AEB 07 – Industry Input

Sensor Misalignment

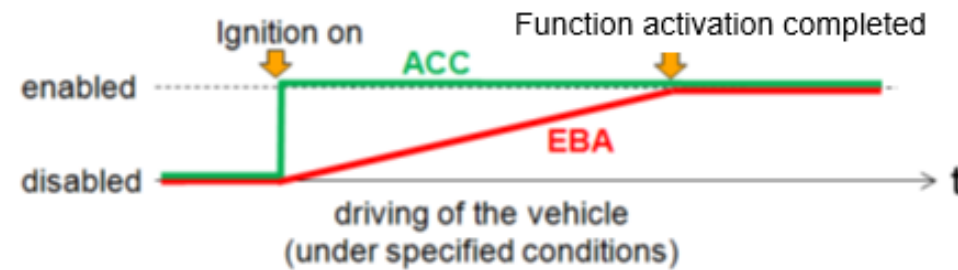
It is difficult to ensure that any non-electric failure can be detected after 300 seconds as this is dependant on the driving condition.

While most conditions, that affect the AEBs' performance, can be detected within 300s of regular urban driving, some conditions may take longer to detect. Also it may be difficult / impossible to detect failure conditions if driving off road or without other road users. e.g. vehicle needs to encounter:

- speed between X-X km/h,
- braking event of X m/s²,
- Corner with radius of X m,
- detect X other road users.

AEBS Braking Requirements

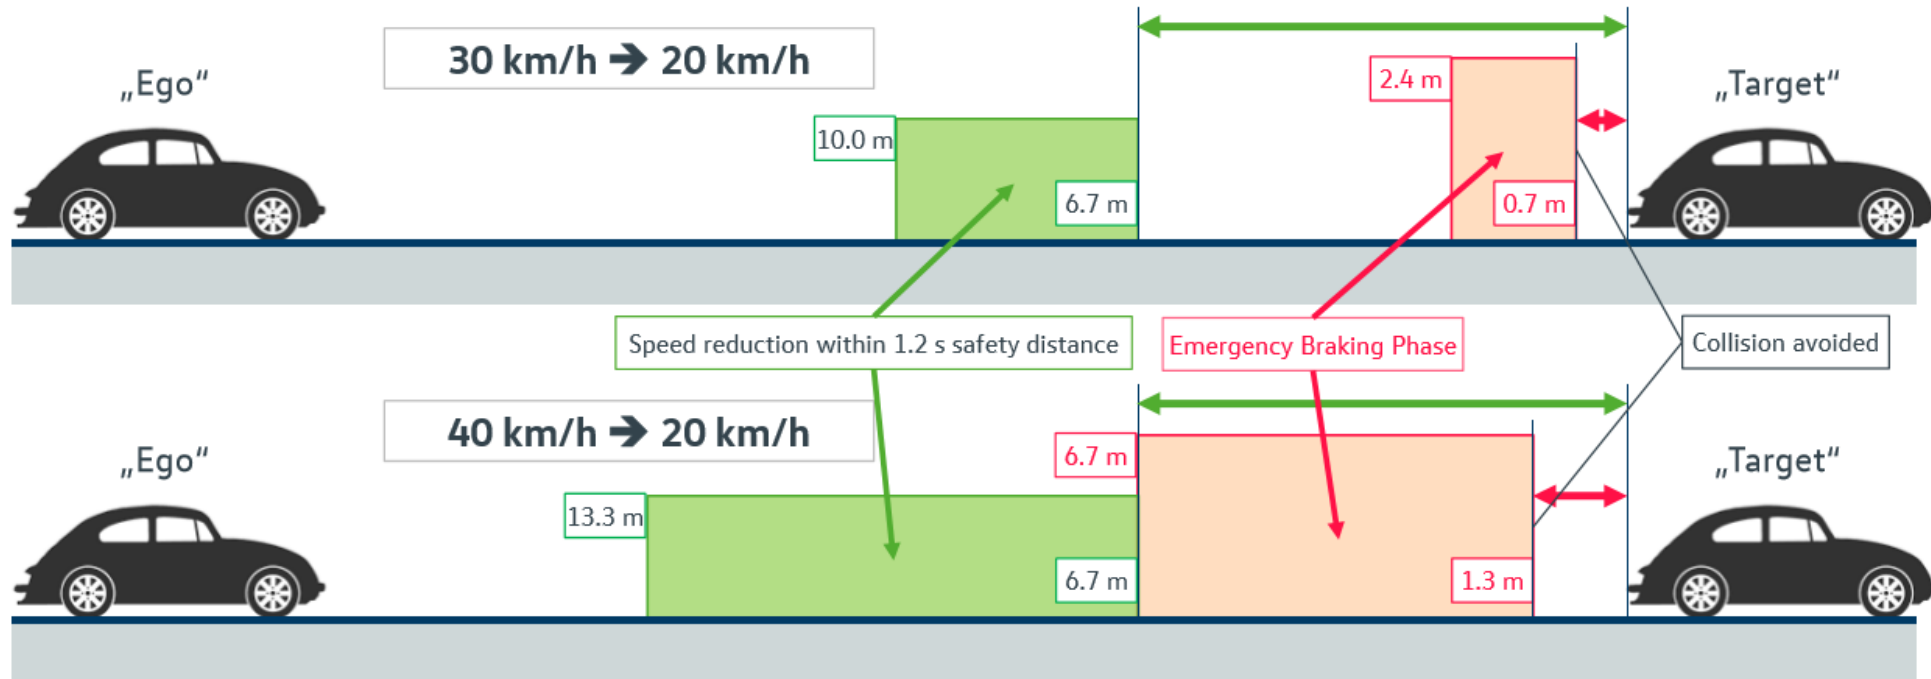
Prevents manufacturers implementing different braking strategies dependent on the vehicles speed and scenario. Manufacturers tend to ramp up the level of deceleration provided by the system over several phases. Lower speed may be different to the strategy used at higher speed.

At lower speeds LTB is behind LTS. So it's possible to brake safe and less harsh after LTS has passed.

May only need slight speed reduction in order to avoid the collision, particularly in crossing scenarios.

Using AEBS as a comfort function is unlikely. The peak deceleration of more than 4 m/s^2 and a remaining gap to another vehicle less than 1 m in an AEB event are uncomfortable for the driver and very uncommon considering normal driving.

CCRm-Scenarios: today in the market, not convenient

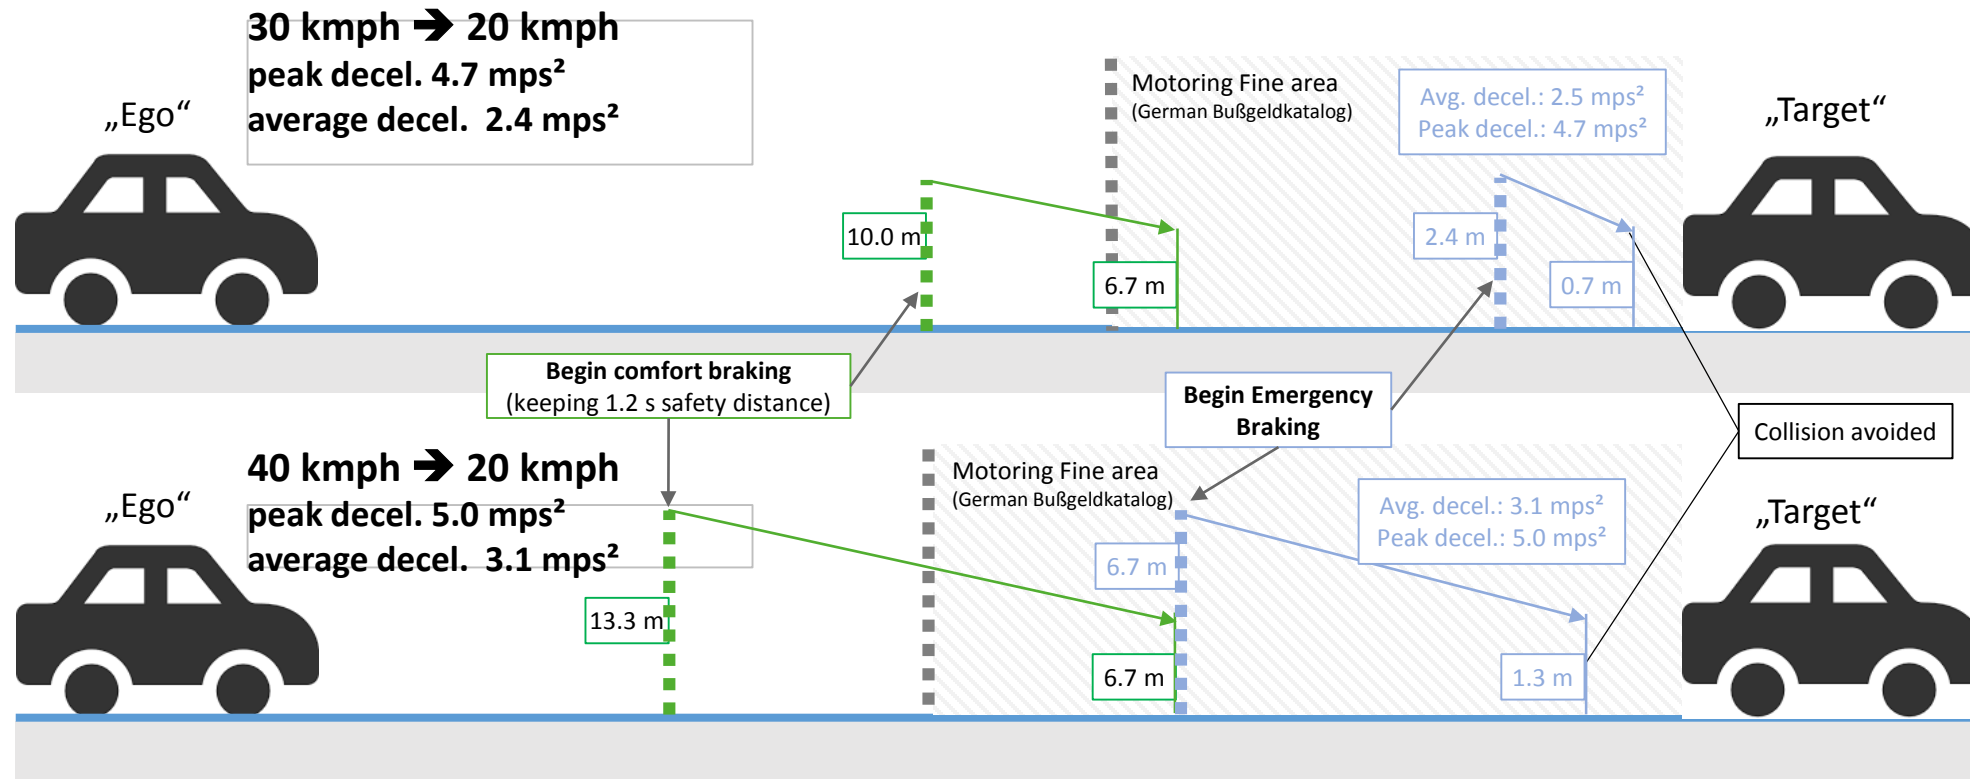
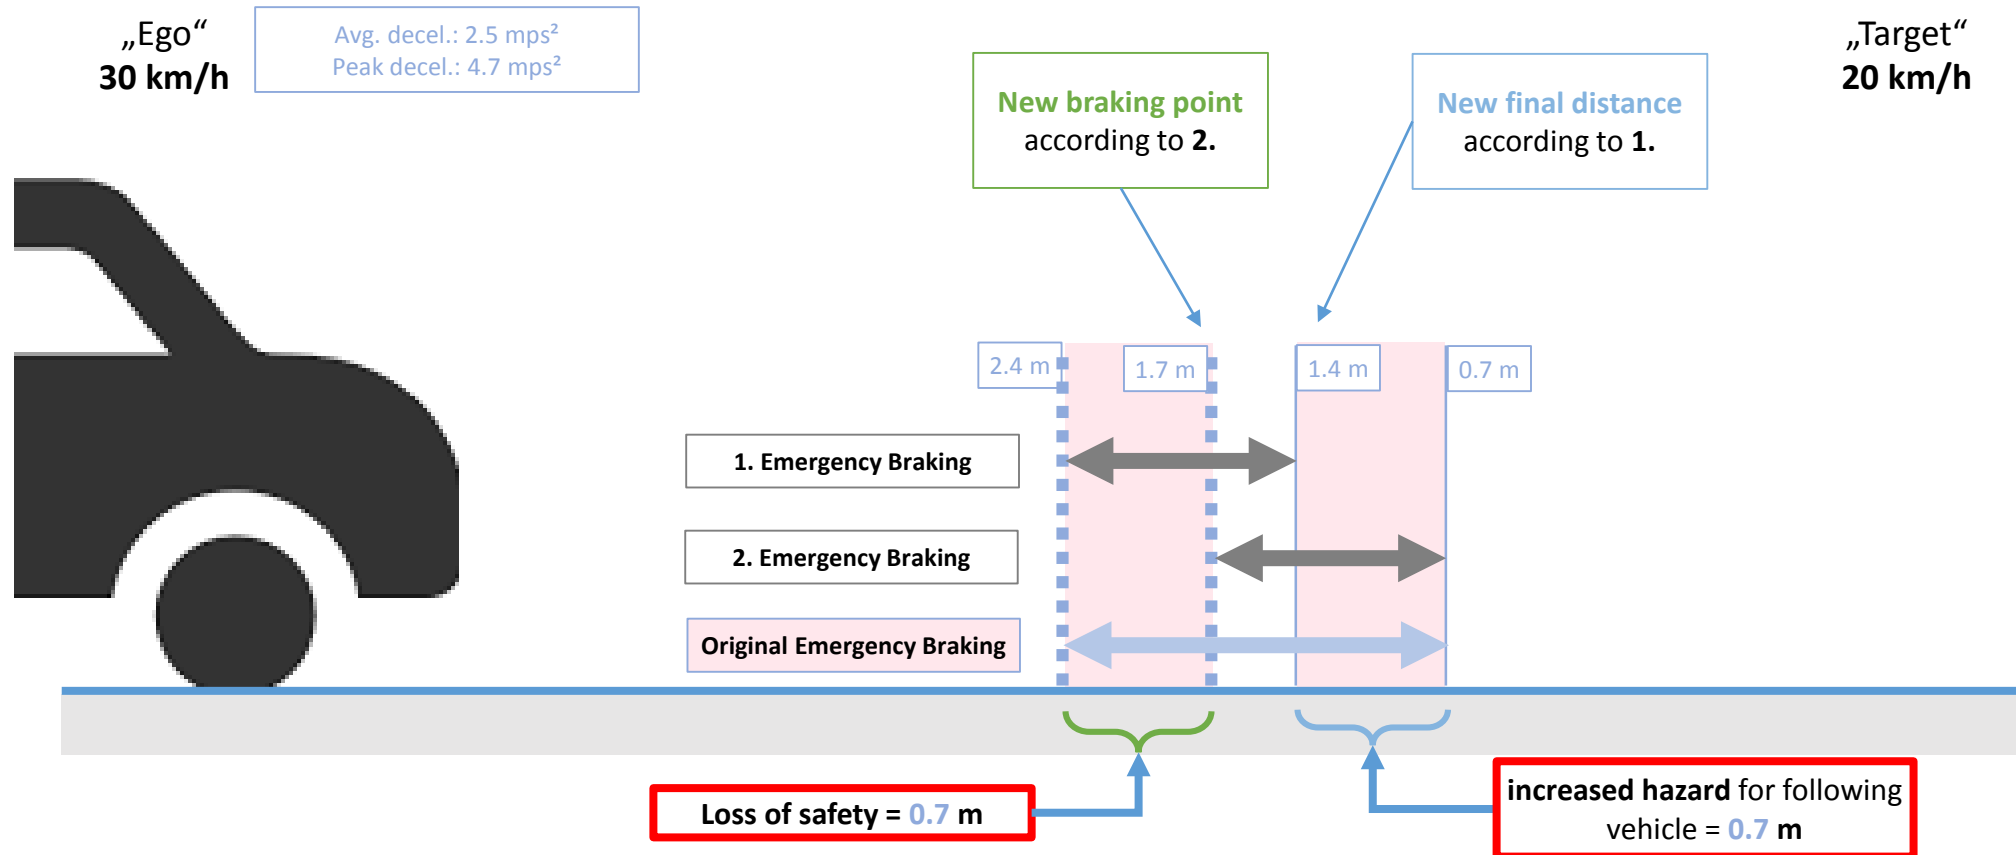
Nevertheless those AEBS are **not considered convenient** – not only because of the level of the deceleration, but because of **starting and ending distance** of the braking phase itself.

In order to reach the demanded deceleration values the AEBS

- has to **brake later** (= loss of safety in case of wet street, changing conditions e.g. braking target, ...) **or**
- will **stop** the vehicle **in greater distance** to the target (=unnecessarily increasing hazard for following vehicles)

Impact of demanded average deceleration (-3.8 m/s^2) on emergency braking in lower speed range.

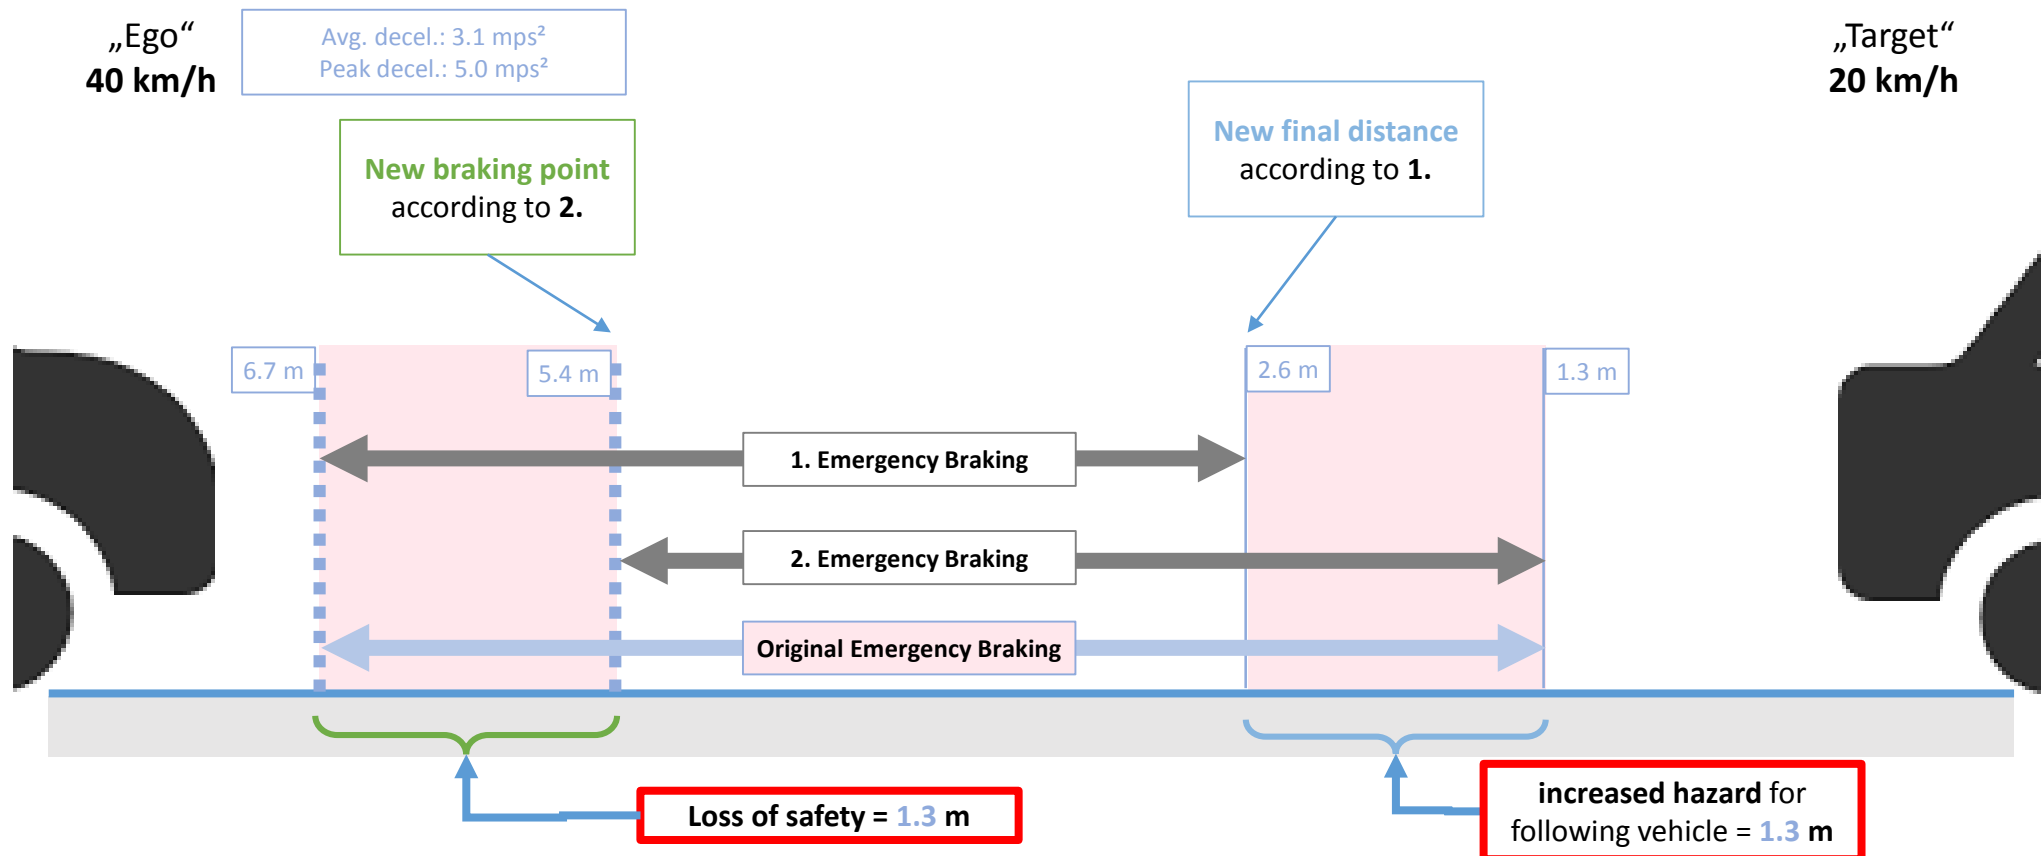
1. Keeping today's begin of emergency braking phase
2. Passing today's emergency braking point in order to keep today's final distance to target

AEBS Braking Requirements

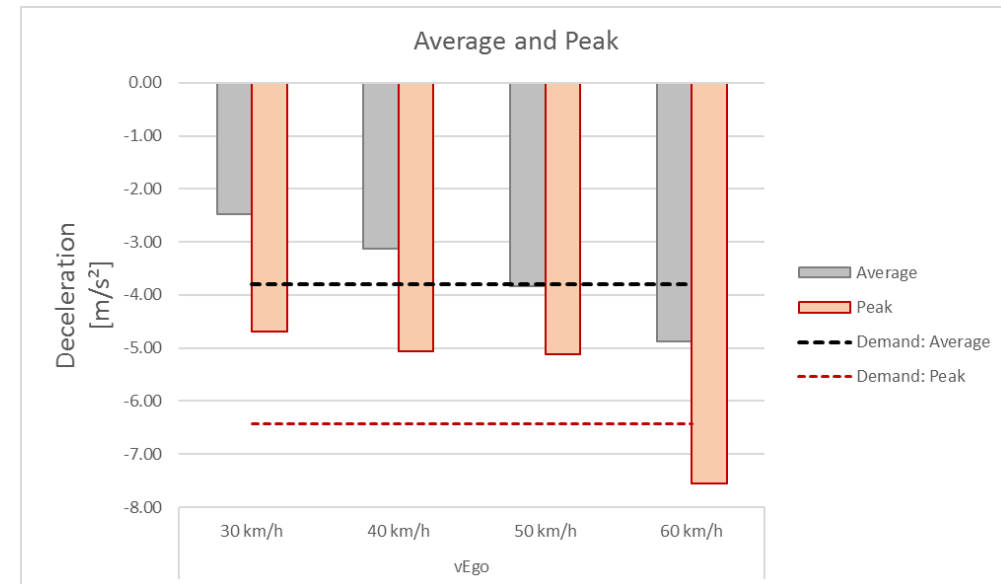
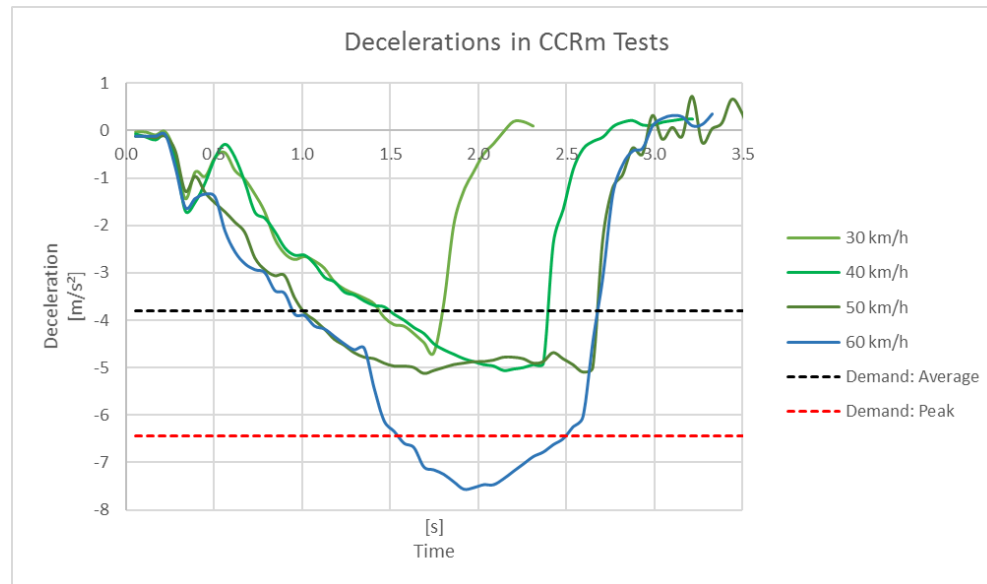
Speeds up to 30km/h relative speed did not achieve the vehicle deceleration required by the draft regulation.

Example (current AEBS):

Braking from 30 km/h to 20 km/h on a moving vehicle

Peak approx. $-4,6 \text{ m/s}^2$

Average approx. $-2,3 \text{ m/s}^2$

Car to Car Reduced Overlap Performance

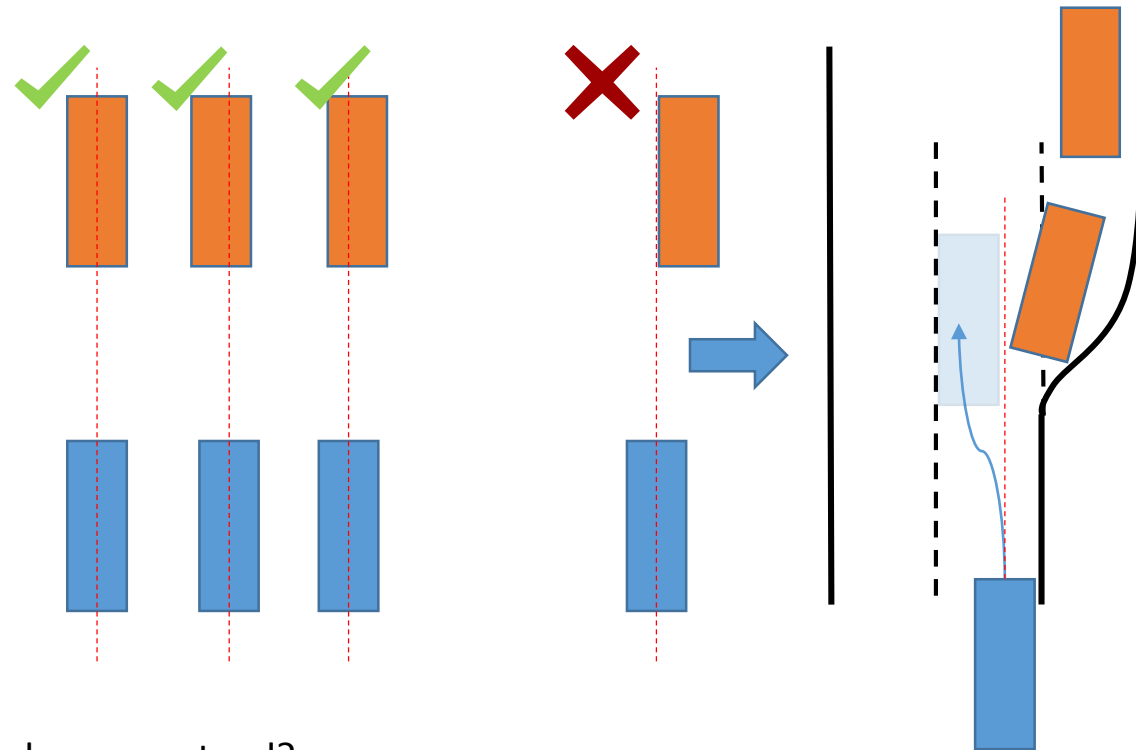
- What happens if the overlap varies?

- Last Point to Steer changes to a later point in time, because less y-distance is needed to steer around.

- What is a reasonable range of overlap, that still resembles the same maneuver?

- +/- 0,25m

- When and why can the max. performance no longer be guaranteed?

- With the last point to steer shifting to a later point in time, the maximum achievable speed reduction decreases

- The risk of annoying the attentive driver is high

- In the sense of an “assistance system” -> when it is not clear that the driver needs assistance, the system should not activate.

Car to Car Reduced Overlap Performance

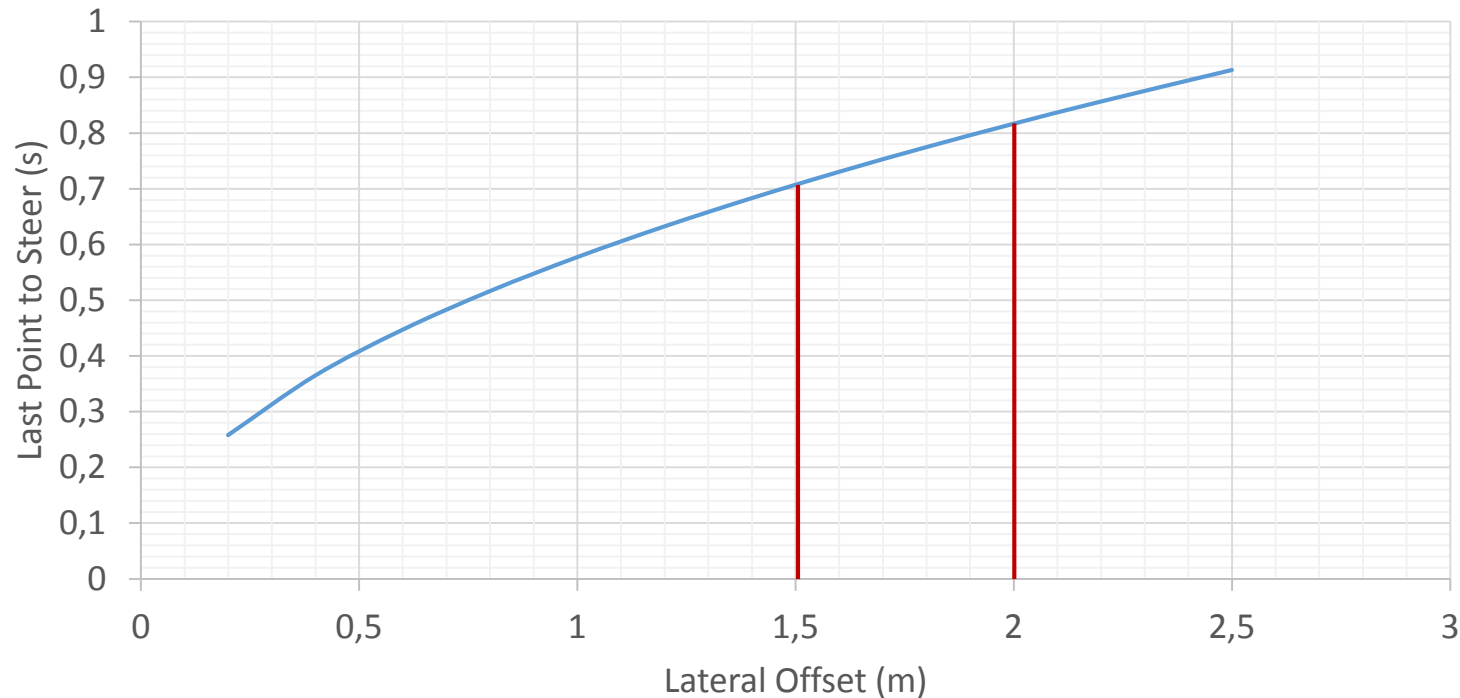
Decreasing the overlap for car to car scenarios, reduces the Last Point to Steer. If manufacturers apply the principle that the vehicle should not brake before either the Last Point to Steer or the Last Point to Brake whichever is latest the speed at which full avoidance is required is reduced.

Cyclist Warning Requirements

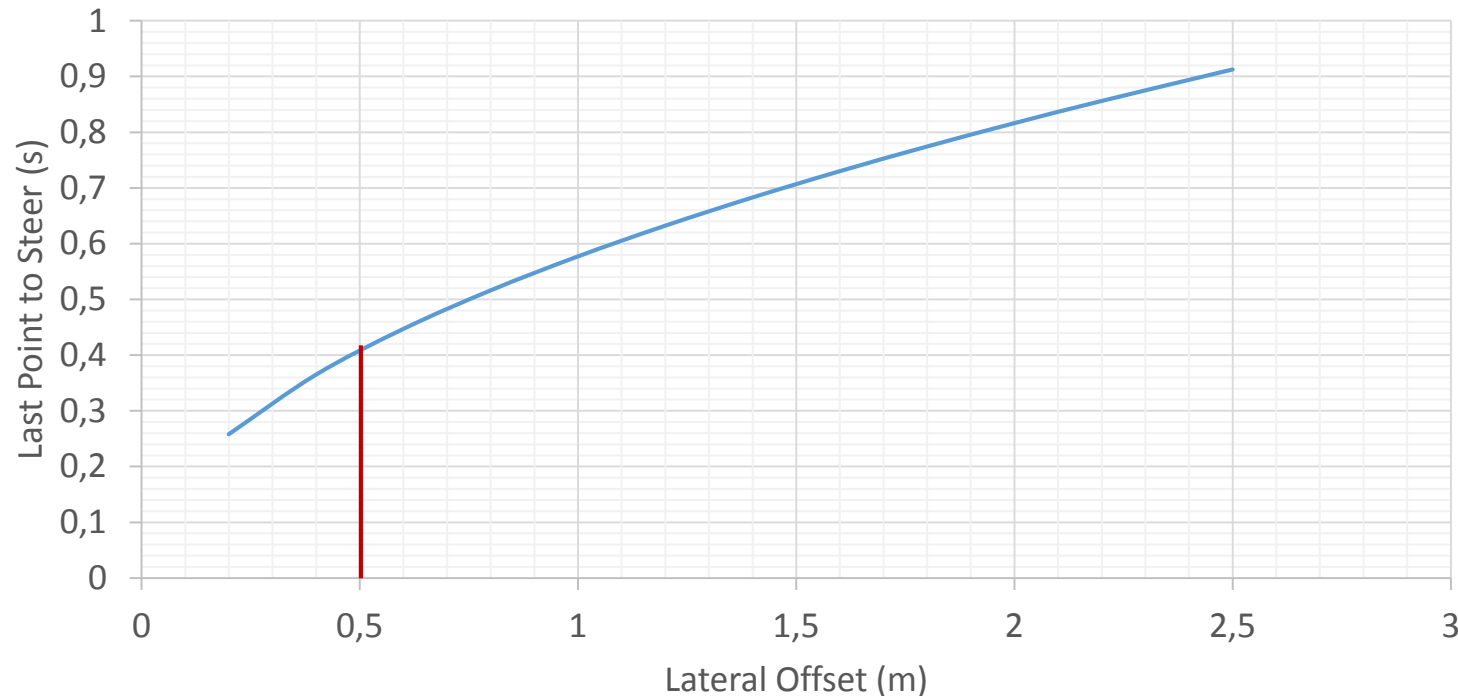
ENCAP test requirements require a warning at the latest 1.7 seconds TTC.

In order to fulfil such requirements in a regulation, manufacturers would need to tune their vehicles to warn at 2 seconds.

2 seconds in the real world may cause unwanted warning interventions.

Industry propose a warning no later than 1.2 seconds before the collision.

This is deemed acceptable as the driver is most likely to steer to avoid the collision at the last point to steer in such a scenario is very late.
